U.S. Department
of Transportation
**Federal Highway
Administration**

In Reply Refer To:
HSST/B-248

Name of system: Modified Thrie Beam Blockout
Type of system: Longitudinal Barrier
Test Level: NCHRP Report 350, TL4
Testing conducted by: Texas A&M Transportation Institute
Task Force 13 Designator: PWB03
Date of request: November 8, 2013
Date of completed package: November 30, 2013

Modified Thrie-Beam Blockout

MODIFIED THRIE BEAM BLOCKOUT

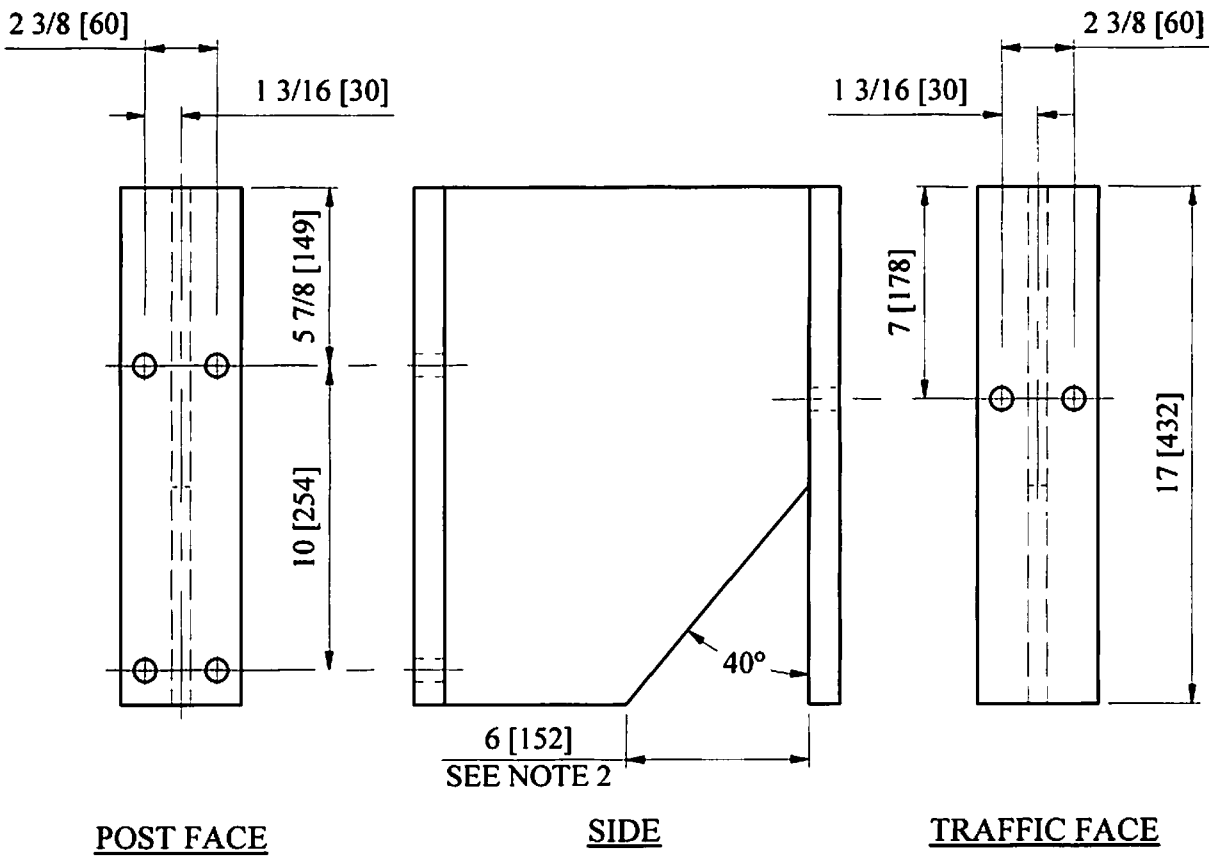
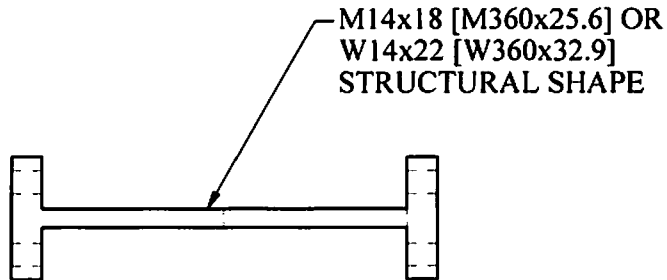
The Task Force 13 designator for this blackout is PWB03. As currently documented, there are no tolerances for the triangular cutout or a defined amount of web material that may remain after the removal process. Typical manufacturing methods leave some amount of web material depending on the process and equipment used.

This component modification defines the maximum amount of web that may be retained and maintain successful crash testing results. Trinity Highway Products, LLC. contracted with Texas A&M Transportation Institute (TTI) to crash test the modified steel thrie beam blackout with a maximum web cutout. Crash testing found that the blackout successfully meet NCHRP 350 Test Level 4 impact criteria.

The tested modified thrie beam blackout was manufactured from standard W14X22 Wide Flange Steel W-Beam that conforms to ASTM A36 specifications. A triangular section seven inches (7") high by six inches (6") deep with a one quarter inch radius (1/4"R) was removed from the web. The triangular cutout begins one and one quarter inches (1-1/4") from the outer edge of the beam flange.

Crash testing confirmed that the manufacturing tolerances of the triangular cutouts that begin flush with the outer flange or any range up to and including this tested distance (1-1/4" from outer flange edge) will behave similarly and provide consistent, successful NCHRP 350 Test Level 4 results. This component modification (defined tolerances associated with the location of the triangular cutouts) for an improved modified steel thrie beam blackout is considered Non-Significant and will have an inconsequential effect.

1. ALL HOLES ARE $\text{Ø}3/4$ [20].
2. TRIANGULAR CUTOUT MAY BE FLUSH AS SHOWN OR OFFSET UP TO $1\ 1/4$ [32] AWAY FROM OUTSIDE SURFACE OF FLANGE AND INCLUDE UP TO A $1/4$ [6] RADIUS AT UPPER INTERSECTION.
